PROPOSED CHANGES TO  
APPENDIX B  
TO OPERATING LICENSE  
NO. DPR-50

## 5.0 Administrative Controls

FIGURE 8

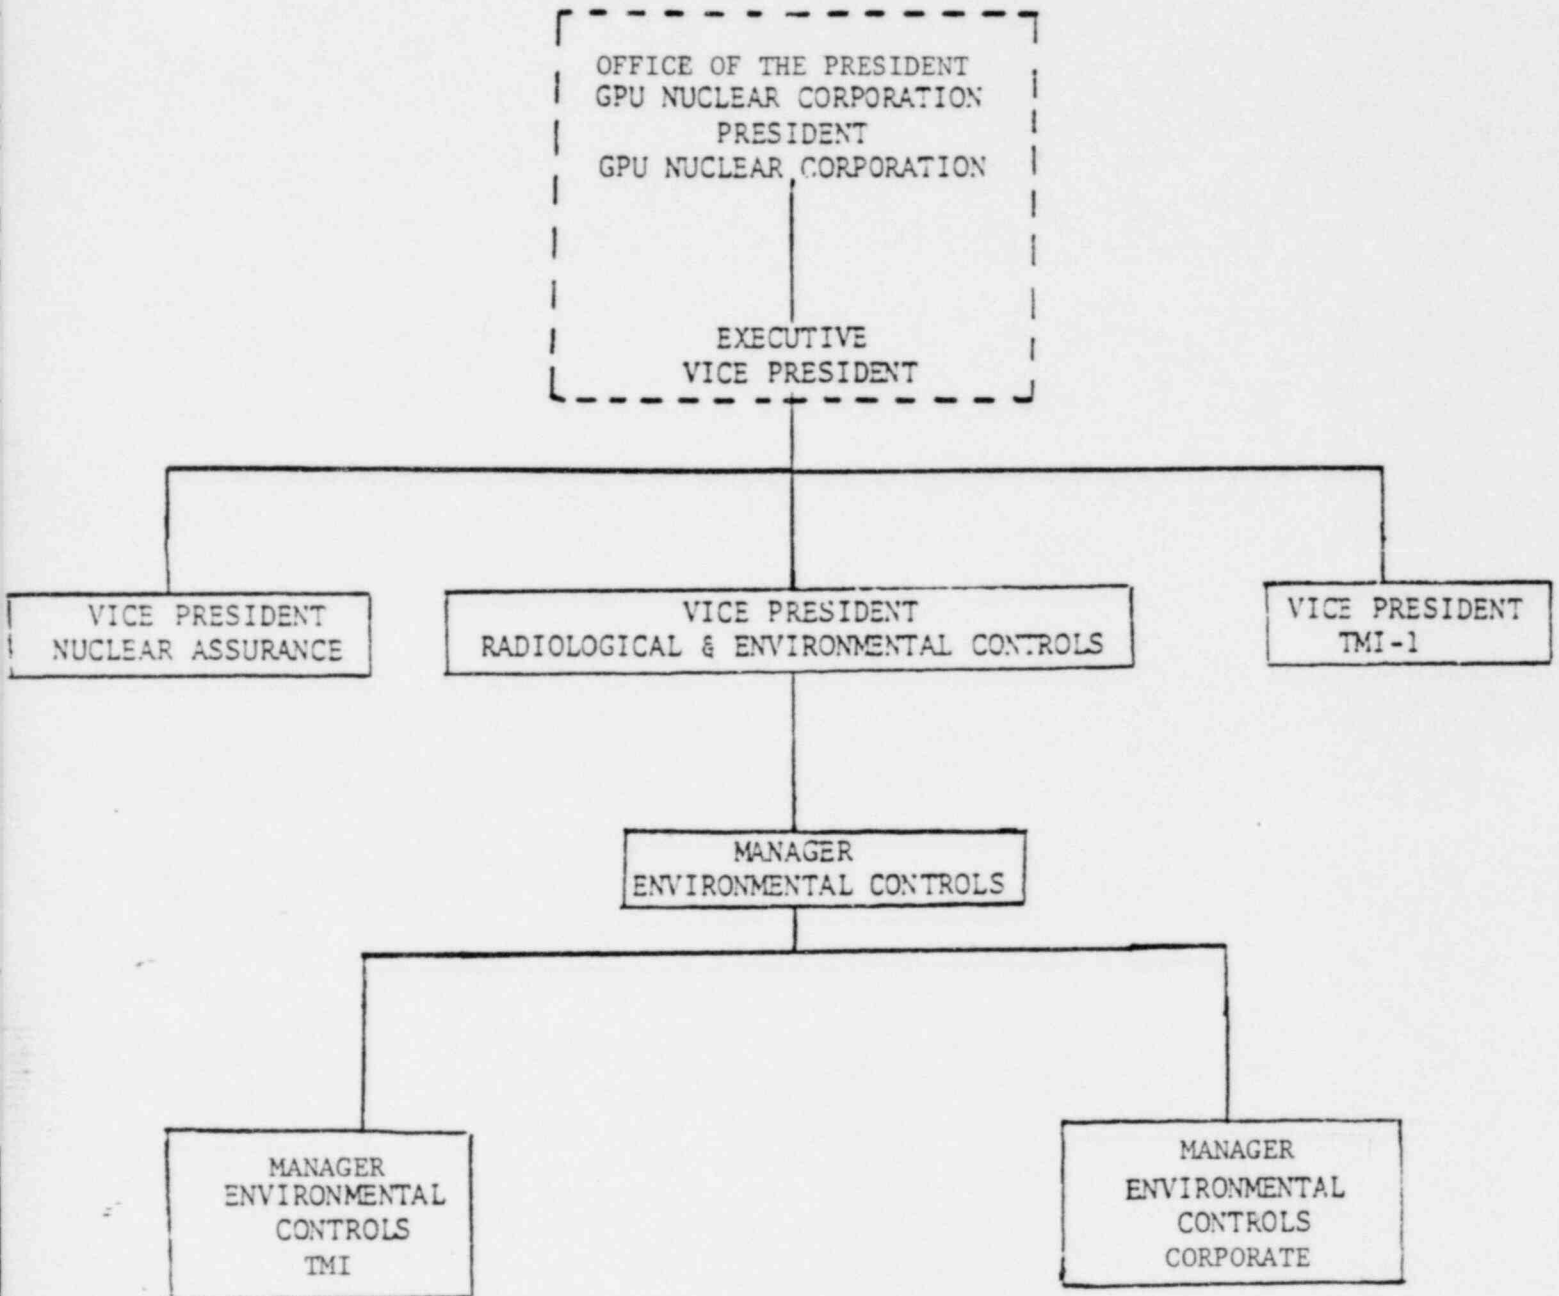
Organization of the personnel responsible for implementation, audit and review of these Environmental Technical Specifications including the Corporate level is as shown on Figure 8 of these Environmental Technical Specifications. In all matters pertaining to compliance with these Environmental Technical Specifications, the Vice President, TMI-1 shall report to and be directly responsible to the Office of the President.
